## COUNCIL ASSESSMENT REPORT

### PLANNING PANEL

<b>PANEL REFERENCE &amp; DA NUMBER</b>	PPSSEC-360 – MOD/2024/0453
<b>PROPOSAL</b>	Section 4.55(2) Modification application to modify Determination DA/2022/0033 dated 28 November 2023. The proposal seeks changes to earthworks and the management of contaminated excavated soil on the site, fill and landscaping works to the southern corner of the park, demolition of a mechanical plenum and associated works to the north-eastern side of the grandstand, other design changes to the grandstand and broadcasters building, removal of bicycle parking and line marking to the car park and other minor modifications
<b>ADDRESS</b>	Henson Park, Centennial Street MARRICKVILLE
<b>APPLICANT</b>	Hamptons Property Services Pty Ltd
<b>OWNER</b>	Inner West Council
<b>DA LODGEMENT DATE</b>	7 January 2025
<b>APPLICATION TYPE</b>	Section 4.55(2) - Modification of consent
<b>REGIONALLY SIGNIFICANT CRITERIA</b>	Clause 3, Schedule 6 of <i>State Environmental Planning Policy (Planning Systems) 2021</i> : Development has a capital investment value of more than \$5 million and Inner West Council is the owner of the land.

Figure 10: DA approved elevation of Grandstand showing retention of existing openings on upper level.

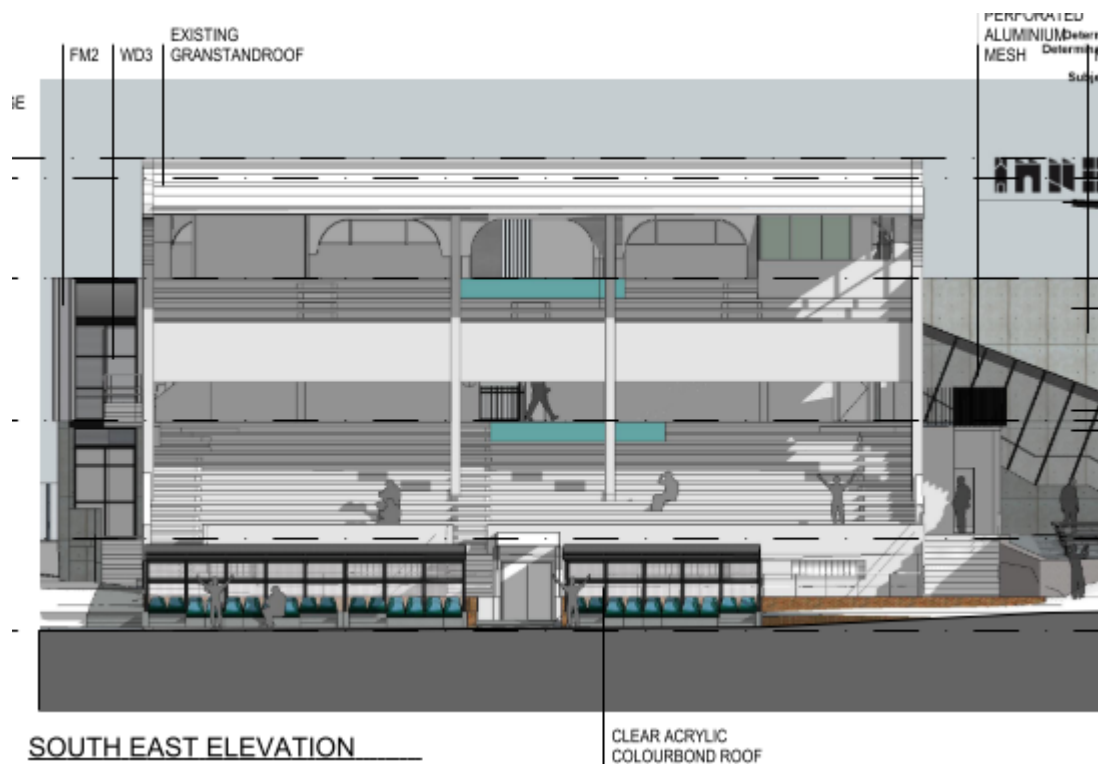
However, Council's Heritage Specialist notes that the removal of an original window and opening to the rear elevation of the existing Grandstand, as proposed and shown on the submitted elevations, will impact on the heritage significance of the Grandstand, physically and aesthetically. Also, it is noted that the heritage advice submitted by the applicant did not address this element.

While the removal of this opening is shown on the Construction Certificate Plans, the drawings and supporting information lodged with the DA (Figure 10) did not identify that the four windows and openings towards the sides be removed and infilled.

Infilling of the openings was also not proposed/mentioned in the supporting documentation submitted as part of the previous Section 4.55 Application (MOD/2023/0247), nor was it depicted on the plans as a proposed modification.

The demolition plans submitted with the subject modification application depict the demolition of these openings.

The applicant has indicated that the infilling of the existing openings is required to achieve the required fire rating between the existing Grandstand and the new additions to the rear of it, which has been confirmed by Council's Building Surveyor after inspecting the site.

To achieve the required fire rating without adversely impacting the heritage significance of the Grandstand, physically and aesthetically, Council's Heritage Specialist supports infilling of the four openings towards the sides of the Grandstand, subject to the form and size of these openings being recognisable in the future by incorporating an indent of 75mm from the windowsill edges to both sides of the openings, and the infill material being painted in a darker shade than the rest of the Grandstand. However, Council's Building Surveyor advised that such an indent from both sides could not be provided while achieving the required fire rating as the existing windowsill has a depth of only 220mm.

Figure 11: Proposed Grandstand side elevation (SW) showing location of window GB W-02

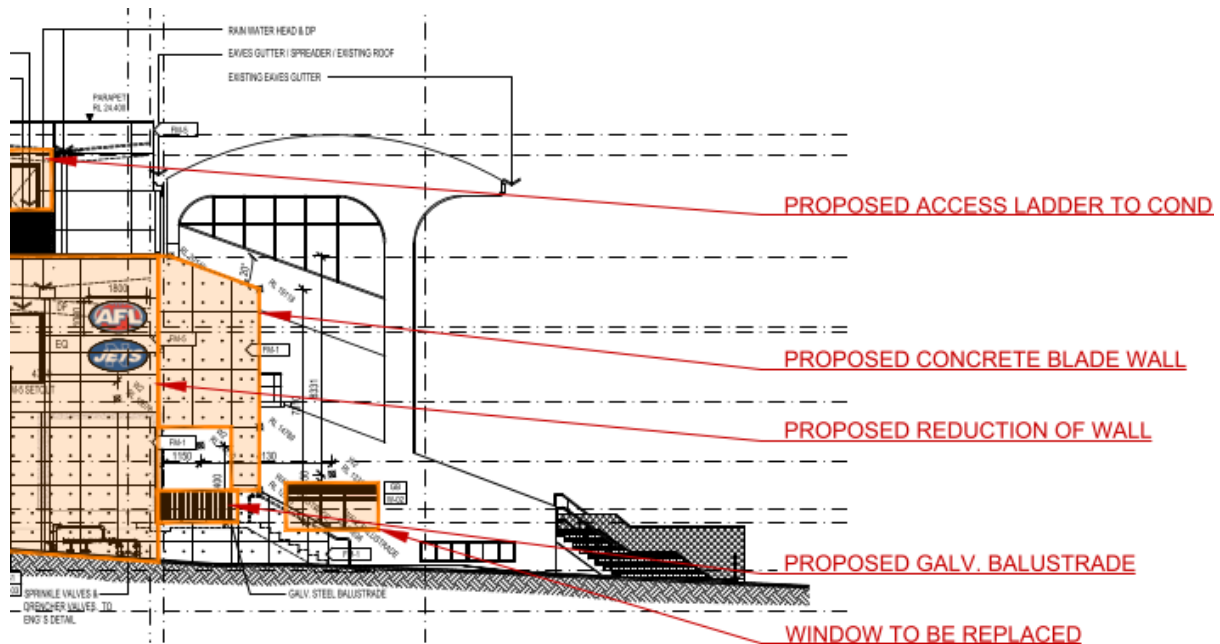
The proposed replacement of the two (2) windows to the side elevations (Figures 11 and 12) of the Grandstand, identified as GB W-02 and GB W-10 is supported on heritage grounds as the window frames are not original, or of significant heritage fabric.

The proposed design of window GB W-02 (as depicted on the 'shop drawings – windows and door schedule 1', prepared by Boka Windows, dated 25/2/2025) is not consistent with original/historic detailing (Figure 13). While no evidence of the original/historic size and materials and detailing of window GB W-10 have been provided by the applicant, it is reasonable to assume that the design of this window was similar to window GB W-02.

As such, to ensure that the design of the replacement windows is generally consistent with the original/historic one (Figure 13), a condition is included in Attachment A requiring that the replacement window BG W-02 consists of 12 individual panes of four columns and 3 rows. Window GB W-10 should consist of four individual panes in a single row. A combination of fixed panes and louvers, similar to the proposed is considered supportable to provide access to daylight and ventilation, which the applicant notes as one of the reasons for replacing these windows. No objections are raised to reintroducing new/refurbished security grilles for safety reasons to these windows.
